# ***Road Safety Audit Report***

## ***Pescadero Creek Road***

## *Pescadero Creek Road Road Safety Audit Report*

*Prepared for  
San Mateo County Department of Public Works*

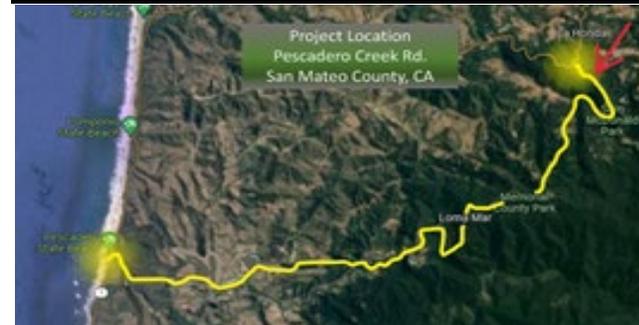
**Observations:** Redwood Drive T-intersection (1 motorcycle crash) - wide throat intersection, lack of channelization, shoulder encroachment, wide pavement, bikes likely use shoulder of 4-6 ft., stop line setback is 10-12 ft from projected edgeline, limiting sight distance looking west, and concern regarding gap acceptance and exposure time to turning traffic leading to intersection conflicts

**Suggested Improvements:** Relocate stop line 5 ft from projected 11 ft. Edgeline. Mark a shorter turn radius and eliminate long tapered edgeline. Double post R1-1 STOP. Consider use of concrete or painted splitter island. Use barrel wrap (black/yellow) around post of splitter island installed STOP. Accommodate transition if needed for shoulder (bike traffic) Effect: Reduce exposure time of turning vehicles, improve sight lines (See Appendix # 7.).

Photo A3 (SMC video; inset FHWA) Above Looking eastbound on PCR just east of Butano Cut-off Rd.; inset @ Butano Cut-off Rd.; Photo A4 (SMC video) Below Looking westbound on PCR approach Alpine Road.

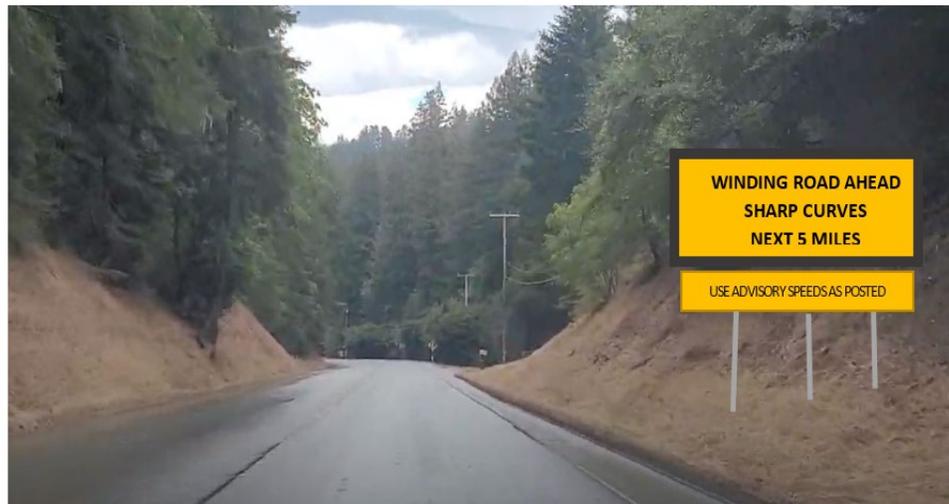
Need for supplemental advance warning signs for downgrade long tangent section approaches to sharp curves. In a few locations the change is evident in ROW, shoulder presence/absent, pavement width, curvature, degree of curvature, driveway frequency, intersection sight distance, etc. Drivers are experiencing a few long stretches of tangent sections between sharp curves, where speeds typically increase. A need exists to warn users. Switchback curve warning sign is seen in distant background (photo A4). This is where a warning sign is needed for change in alignment with reminder after switch back in next tangent section. Sign Design,

At least two long tangent sections (Lat-Long Coordinates provided below) downgrade can increase the possibility of a lane departure in a curve. Motorists sometimes increase their speed in longer tangent sections between curves on winding roads of considerable length. Provide upstream advance notice. Suggestion SHARP CURVE AHEAD/REDUCE SPEED TO XX MPH. Follow with standard horizontal warning sign at advance preview distance Table 2C-4, MUTCD Fed.

Note: These proposed signs as depicted in Photos A5-A6 would supplement, not replace, the necessary warning signs to be installed according to the curve analysis study recently performed by a contractor. Photos below show suggested type of warning sign superimposed onto photos

Image A8 - Loma Mar Section , Segment 5,

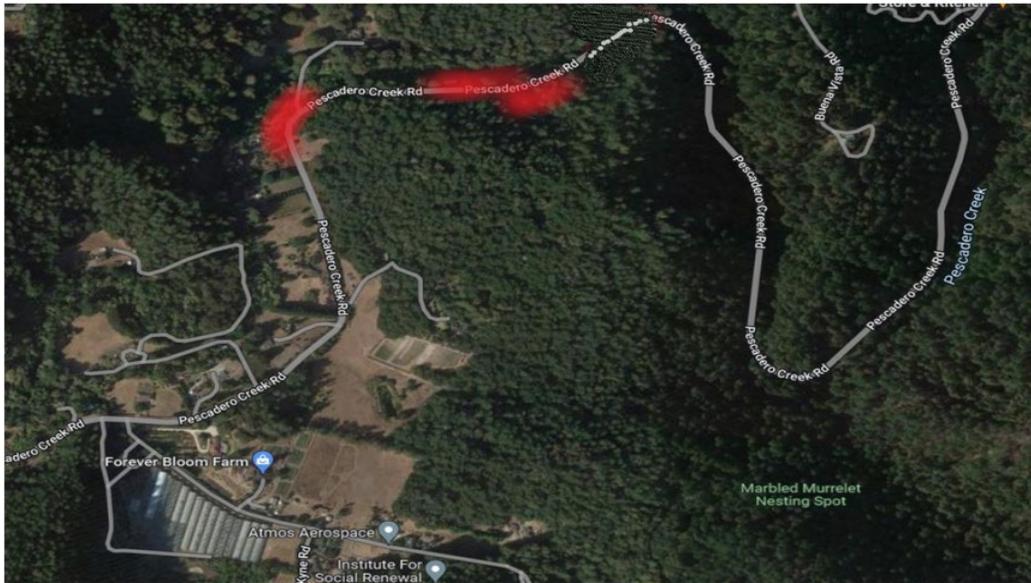
Numerous locations were noted during the ride-through portion of the field review. A guardrail/barrier analysis should be conducted to determine how many additional sites may be candidates for redirected barrier. Red areas marked on map indicates sites for barrier or other roadway departure countermeasure consideration. Sections are Loma Mar and LaHonda.
